REPRESENTATIONS MADE ON BEHALF OF
BARRATT STRATEGIC

DOVER DISTRICT COUNCIL'S
WHITFIELD SUPPLEMENTARY PLANNING DOCUMENT
CONSULTATION DRAFT MASTERPLAN

NOVEMBER 2010

Site Location Plan

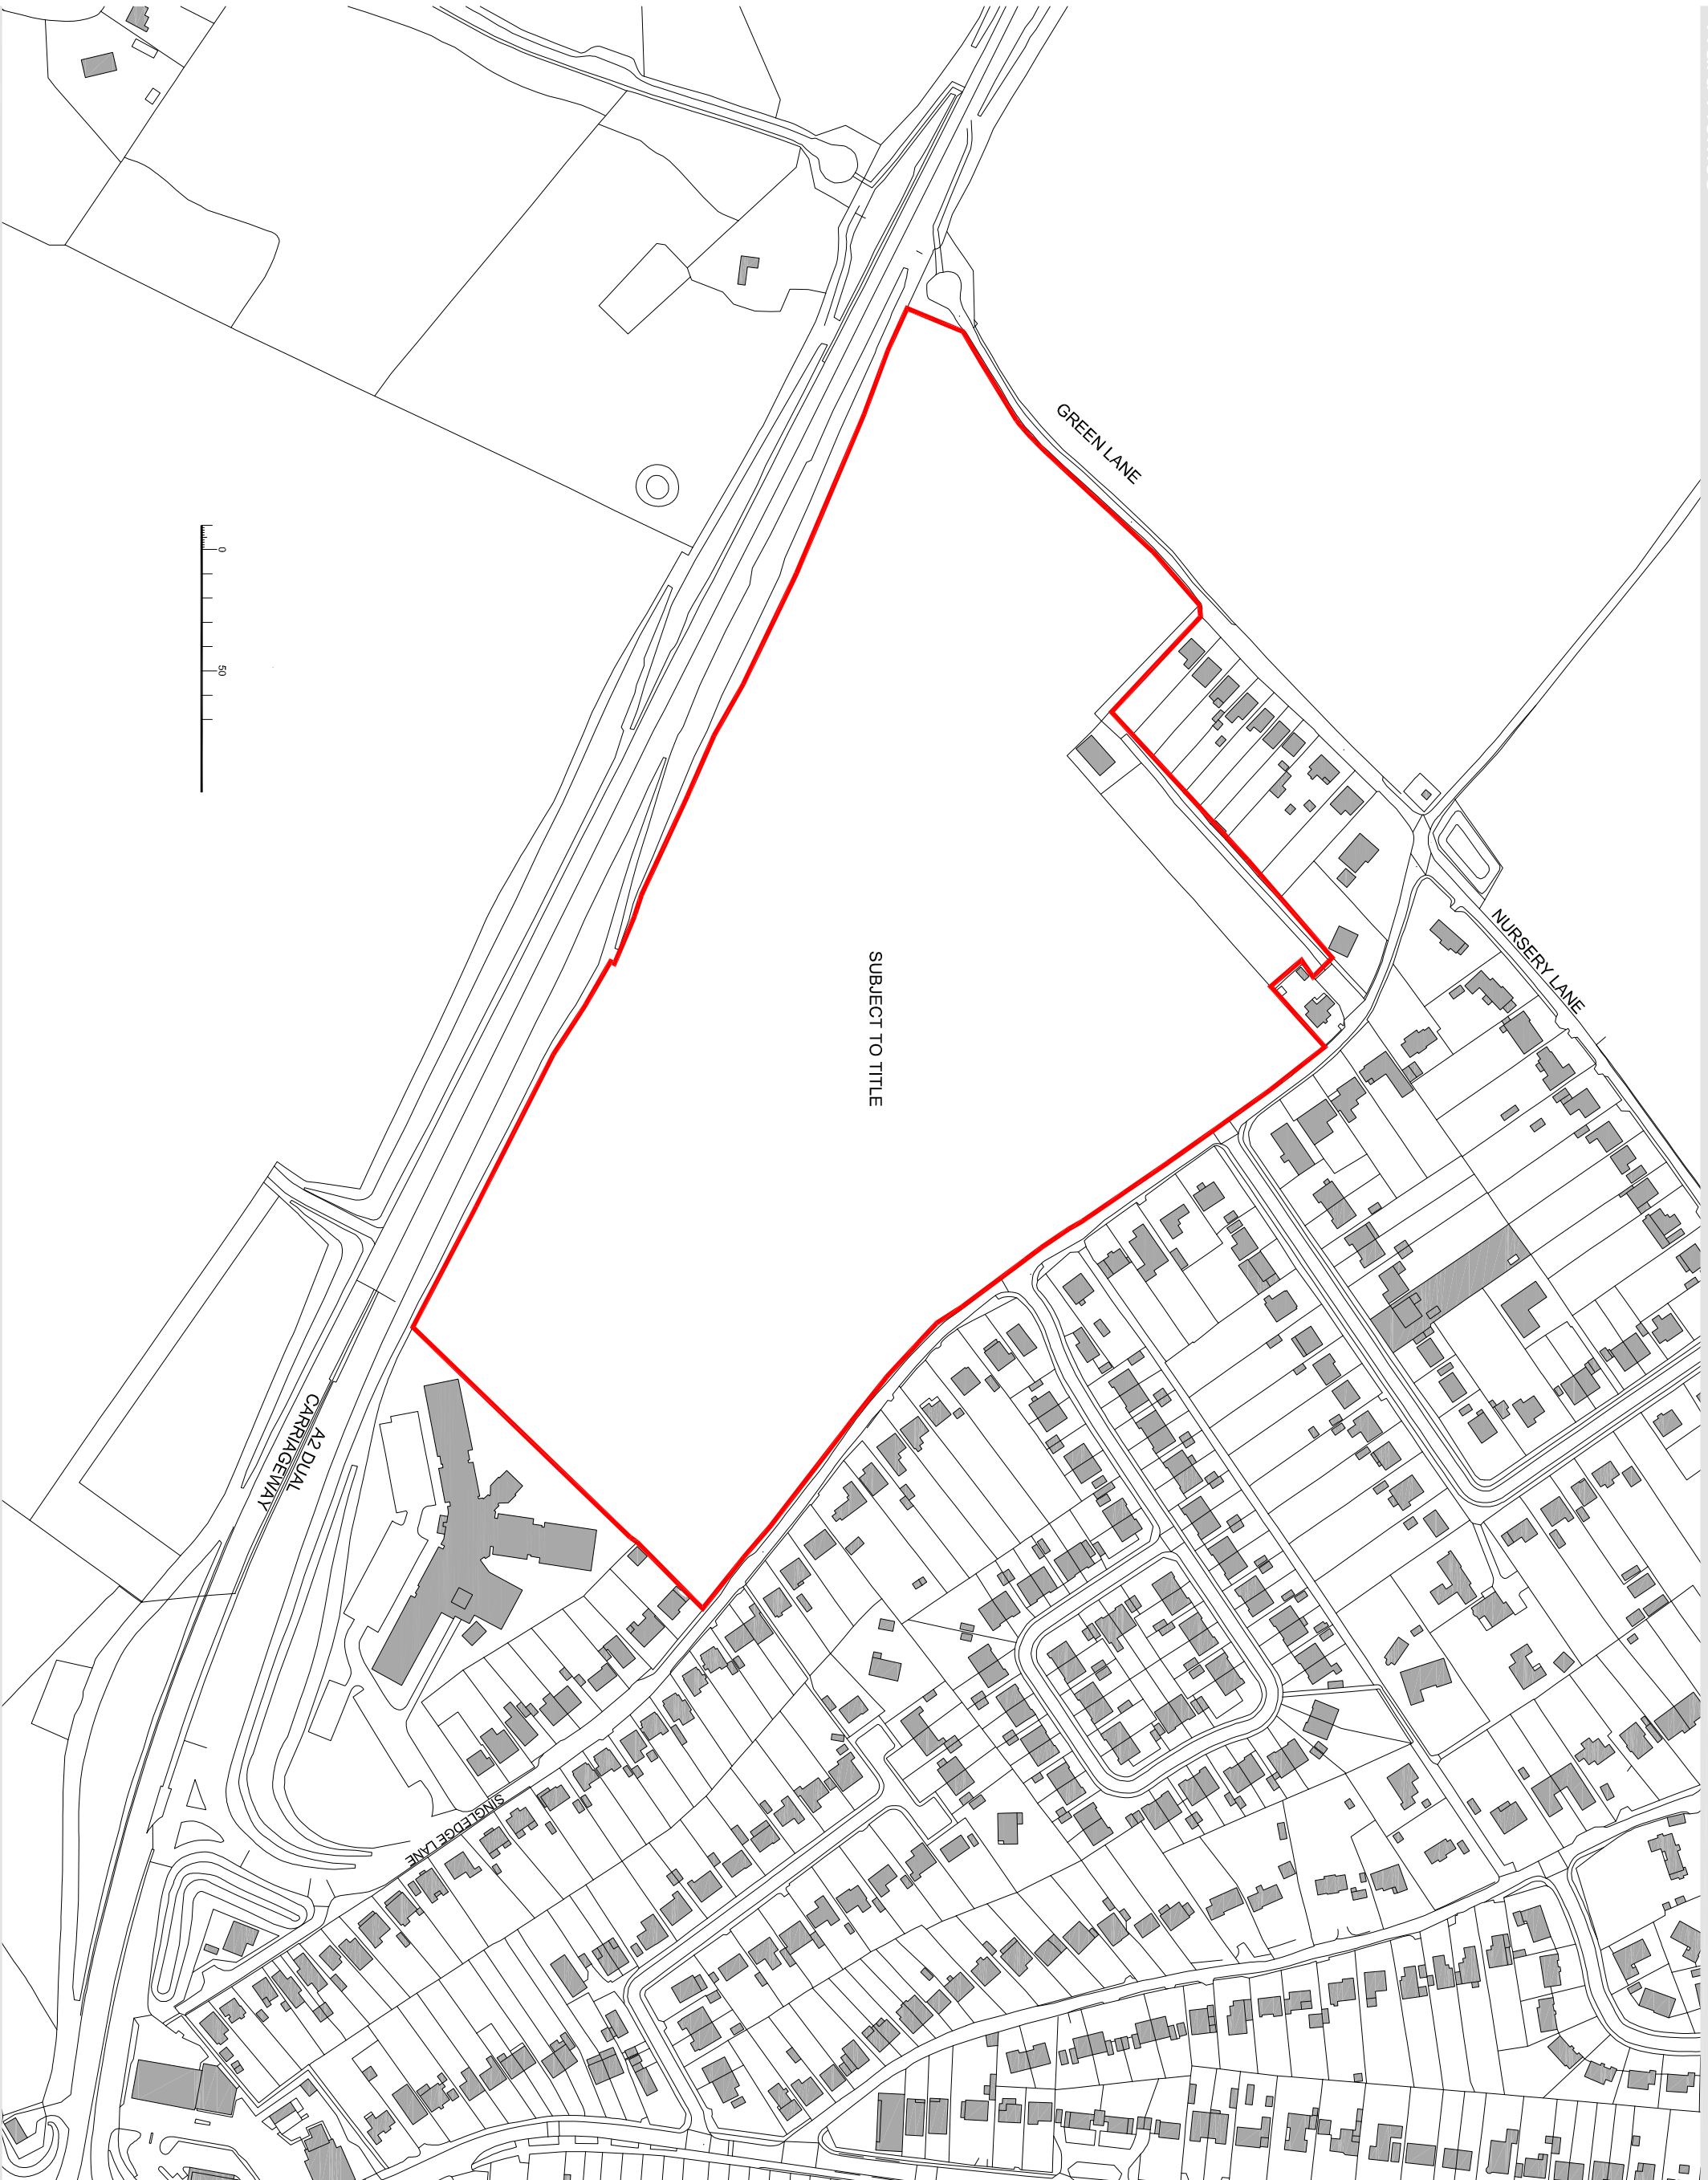
- 5.1 The boundary of the extension to the south of Singledge Lane shown in Figure 9.9 needs to be amended to include the curtilage of 'Bonne chance'. Figure 9.9 in the final SPD should accord with the attached Site Location Plan (appendix 1).
- 5.2 In general some of the figures in the SPD include 'Bonne Chance' as part of the SPD area, for example figures 6.1, 6.2, 6.3, 6.4 and 6.5, whilst some of the figures exclude 'Bonne Chance', for example the Options in Section 7 and figures 9.1 and 9.2 in addition to figure 9.9.
- 5.3 The SPD should be consistent in its definition of the extent of the site to the south of Singledge Lane and therefore 9.9 and all figures should show the site boundaries to include 'Bonne Chance' in accordance with the attached Site Location Plan (appendix 1).
